**Revised Phase B Site Investigation
Work Plan
Text, Tables, and Figures**

**Tronox LLC Facility
Henderson, Nevada**

Subject: Revised SAP Tables, Figures and Plates for the Phase B Source Area Investigation Work Plans for Areas I, II, III and IV, Tronox LLC Facility, Henderson, Nevada (Facility # H-000539)

Re: **Tronox LLC (TRX)**
NDEP Facility ID #H-000539
Nevada Division of Environmental Protection (NDEP) Response to:
Phase B Source Area Investigation Work Plan, Area I (Northern LOUs), Tronox LLC
Facility, Henderson, Nevada
Dated April 3, 2008

SHEET NUMBER	1
FIGURE NUMBER

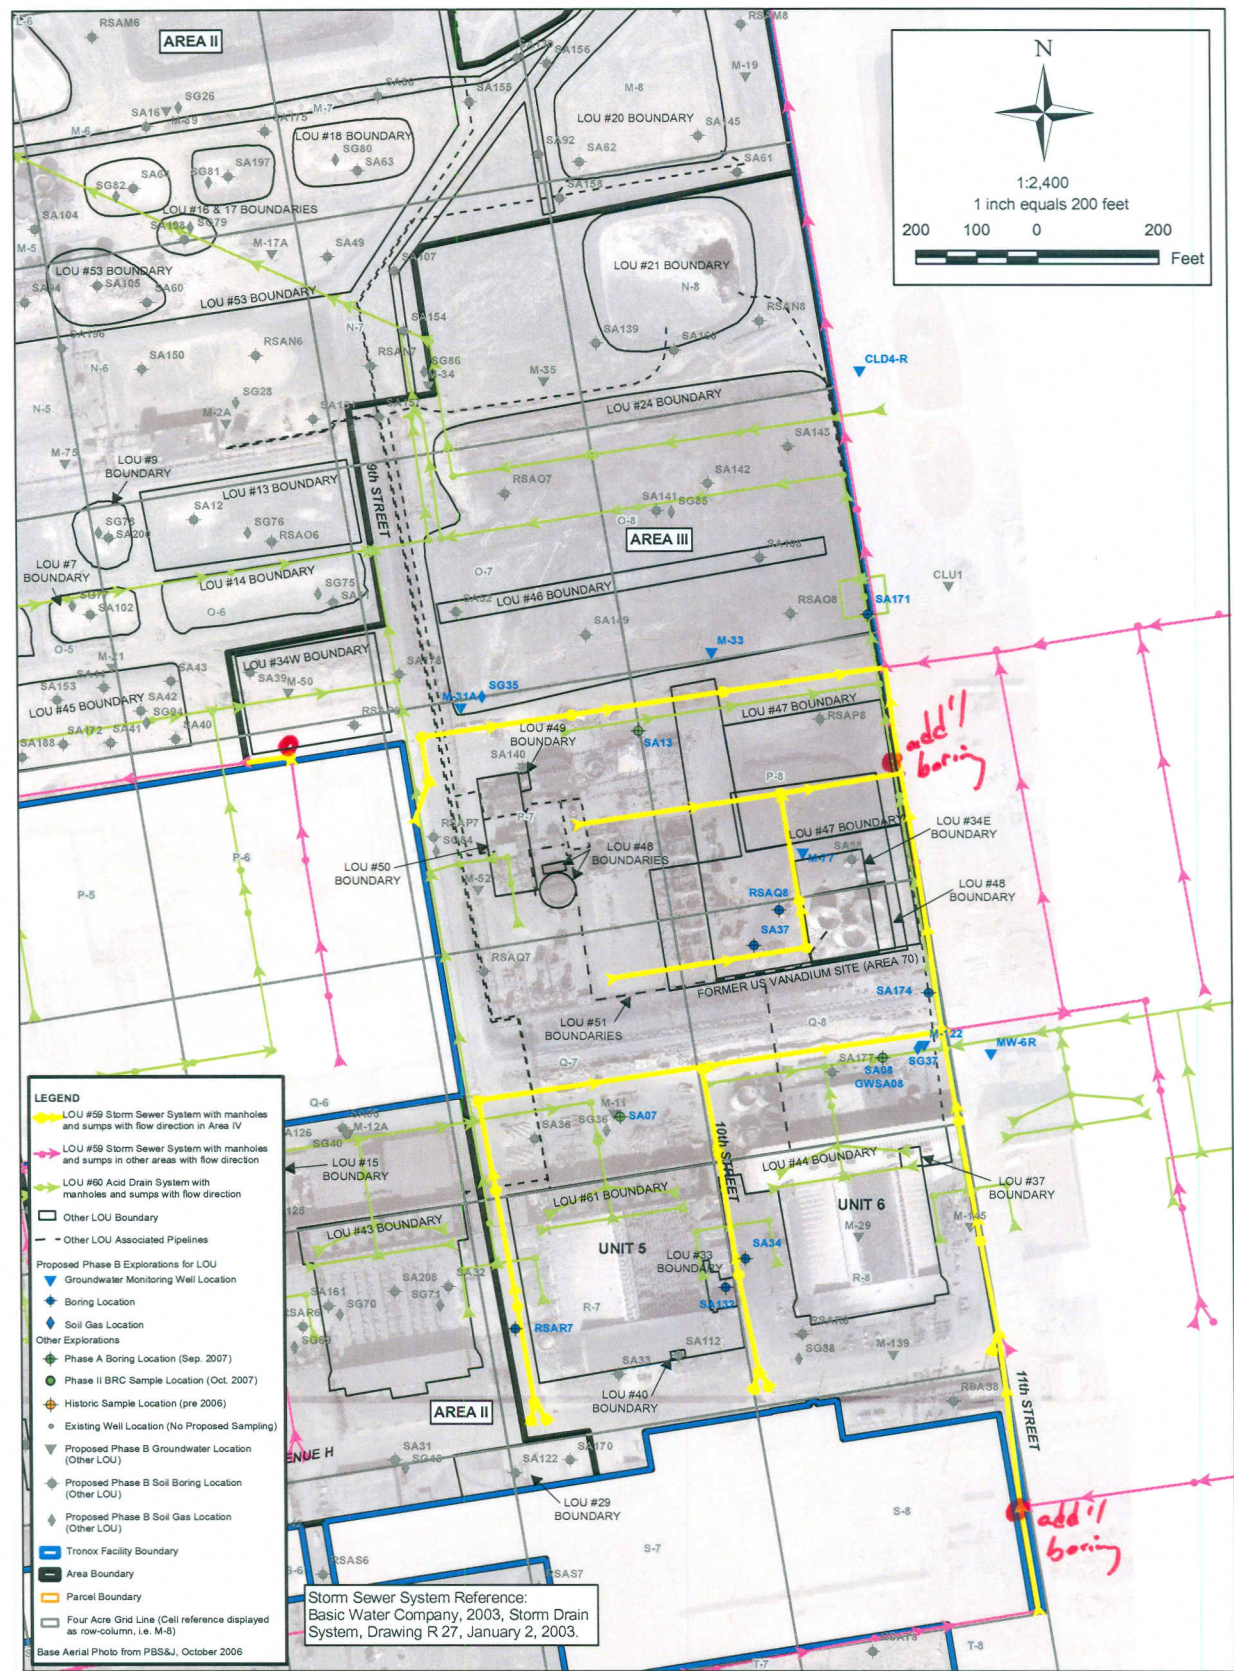
additional boring south of LOU 34W at 90° North of a clean star.
 additional boring at junction on east side of LOU 47.
 additional boring southeast portion of LOU

SHEET NUMBER	1
FIGURE NUMBER

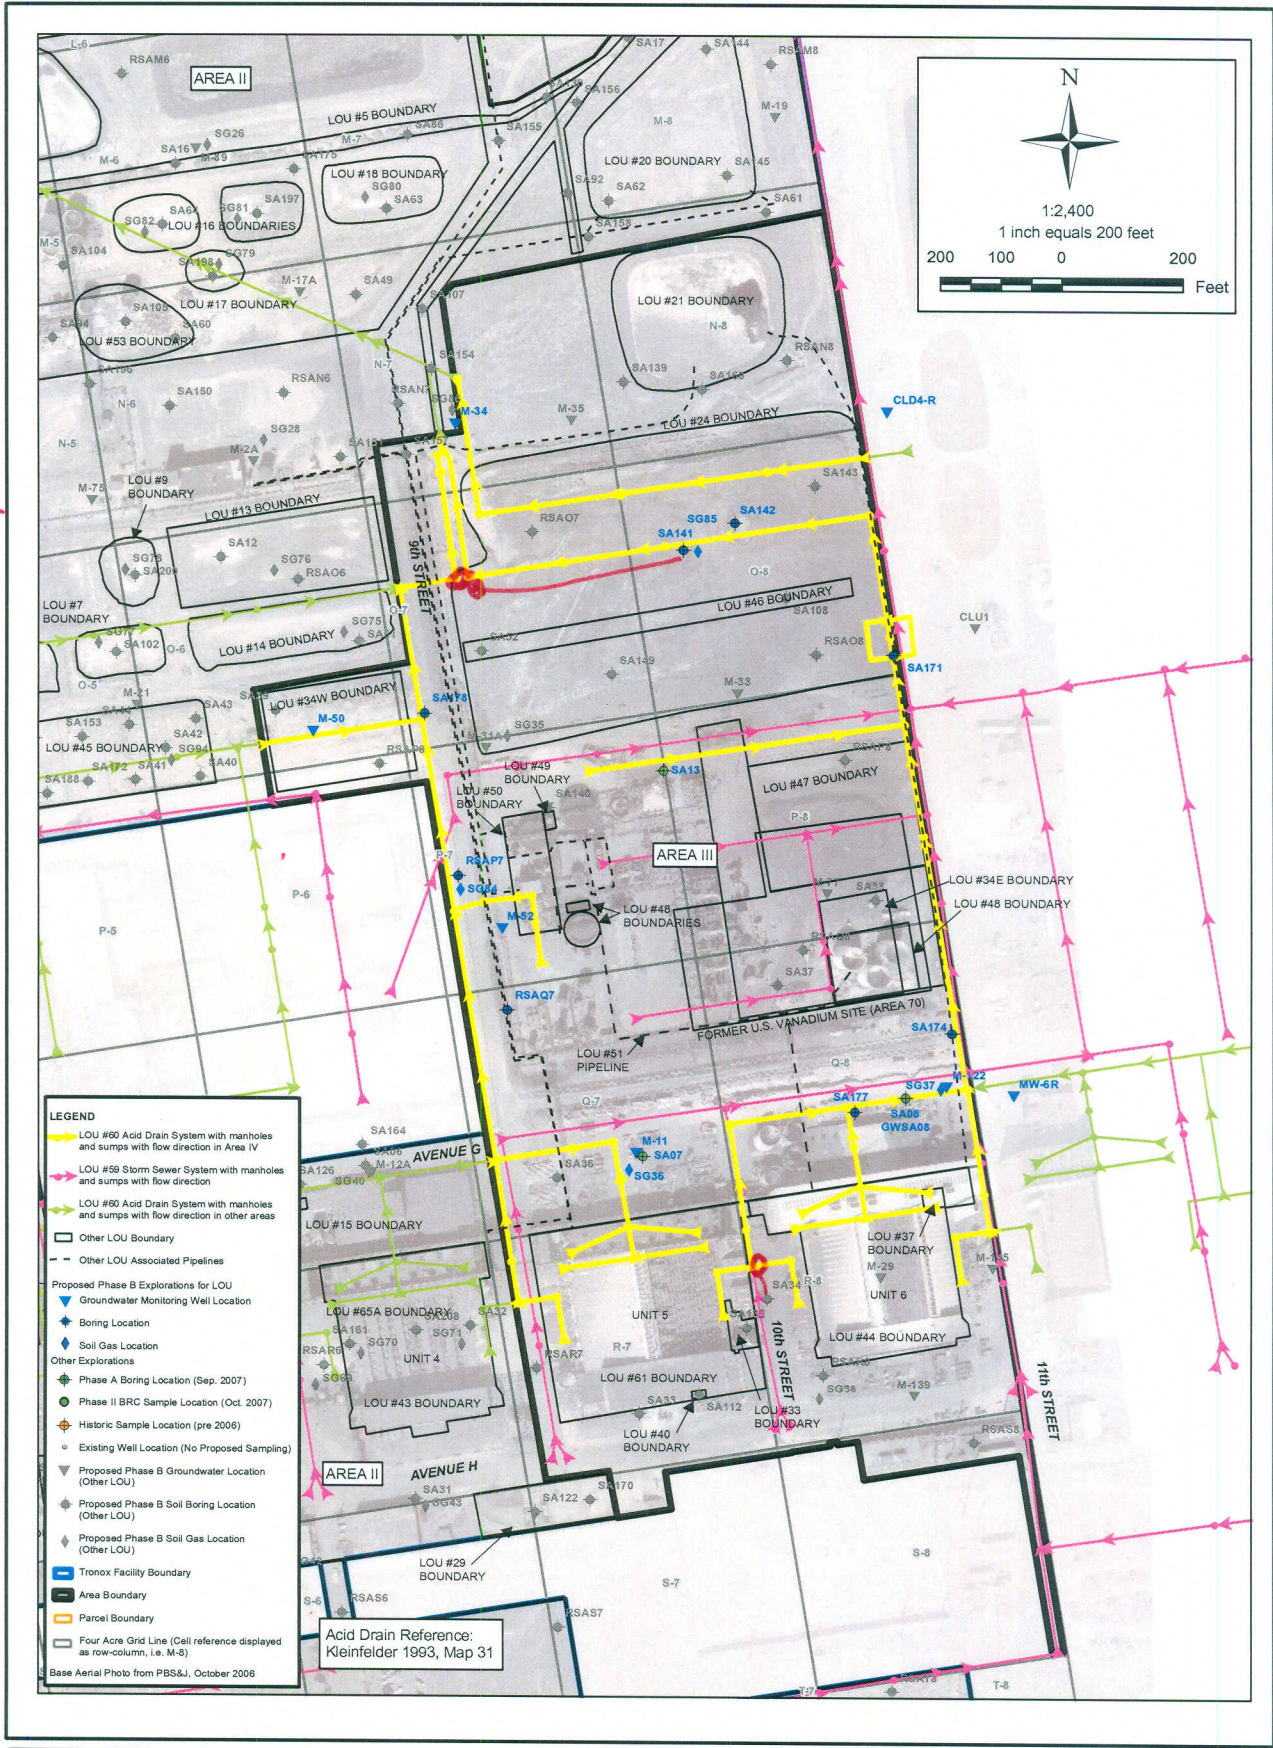
move SA141 west to the two legs of Lou60.
 move SA34 north over Lou60.
